## Proposal for amendments to working document GRSG/2025/51 (Draft Proposal for a new UN Regulation on the approval of a vehicle type with an advanced driver distraction warning system)

The modifications to the document GRSG/2025/51 of the Regulation are marked in **bold** for new characters.

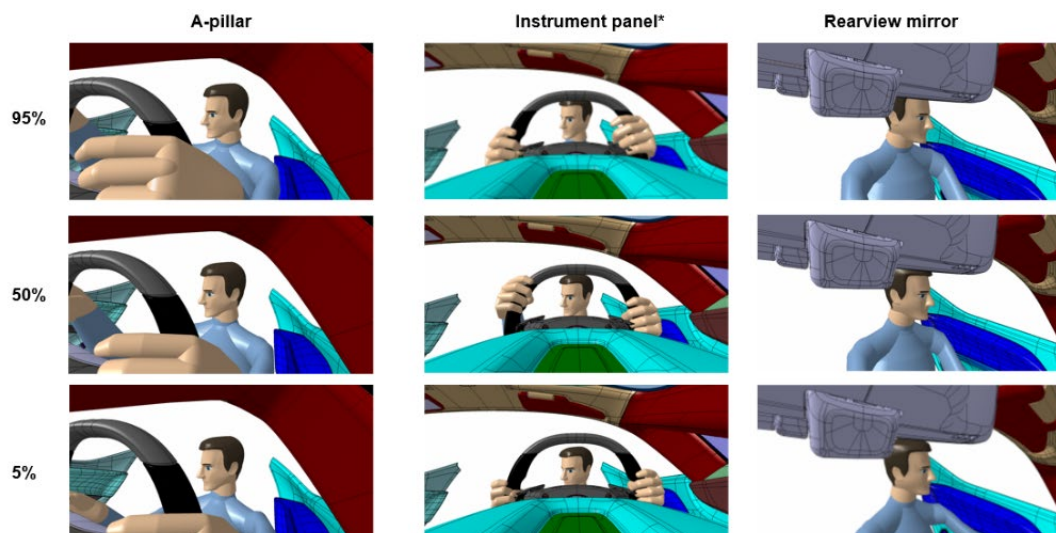
2. At-the-date, ADDW systems are mainly based on a camera sensor able to monitor the driver's gaze. In order to fulfil ADDW performance/testing requirements, camera-system should be able to monitor **both driver's eyes**. Considering the peculiar cabin architecture of high

performance vehicles (e.g. thinner and very tilted “A” pillar, smaller field of view, low volume cabin compartment), the following images show cases where the gaze of the driver, looking at the boundaries of the distraction zone as define by the GRSG/2025/51 proposal, is not fully visible (i.e. both driver’s eyes) for most common camera-installation positions in a car. This could lead to false positives, system unavailability.

- "1. Scope
  - 1.1. This Regulation applies to vehicles of category M and N.
  - 1.2. This Regulation is without prejudice to requirements of national or regional laws related to privacy, data protection and personal data processing.
  - 1.3. This Regulation does not apply to
    - 1.3.1. vehicles of category X and Y;
    - 1.3.2. **vehicles of category M and N where the "R" point of the driver seat is not more than 450 mm from ground level.**
